# UNITED STATES PATENT AND TRADEMARK OFFICE

APPLICATION NO.	FILING DATE	FIRST NAMED INVENTOR	ATTORNEY DOCKET NO.	CONFIRMATION NO.
09/847,759	05/02/2001	Mark J. Hall	HANBEV.002RA	6043
20995 7590 09/21/2009 KNOBBE MARTENS OLSON & BEAR LLP 2040 MAIN STREET FOURTEENTH FLOOR IRVINE, CA 92614				
EXAMINER STRIMBU, GREGORY J				
ART UNIT 3634		PAPER NUMBER		
NOTIFICATION DATE 09/21/2009		DELIVERY MODE ELECTRONIC

### Office Action Summary

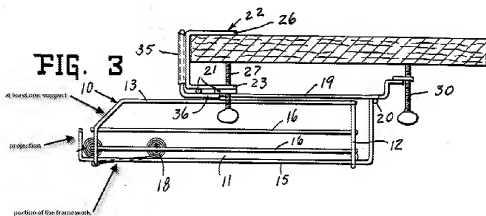
However, Dickson discloses a shelf structure configured to rest on and engage a shelf which is horizontal or inclined, the shelf structure comprising:

- a framework 15 defining a second plane;

- a front rod member 21, at least one other rod member 21 rearwardly spaced from the front rod member, at least a first panel member 23 extending along the front rod member and a second panel member 23 extending along the at least one other rod member, the front rod member, the at least one other rod member, the first panel member, and the second panel member defining a first plane and being configured to support additional shelving above the first plane, the first and second panel members also being configured to support the shelf structure from one of said fixed or adjustable shelves with the shelf structure disposed below said one of said fixed or adjustable shelves as shown in figure 3; and

- at least one support (labeled below) connecting at least the front rod member 21 and the framework 15, wherein at least a portion of the framework (labeled below) extends at least forward of a projection 36 of the front rod member 21, and a stop (labeled below) on the projection extending in a direction from the second plane toward the first plane (16);
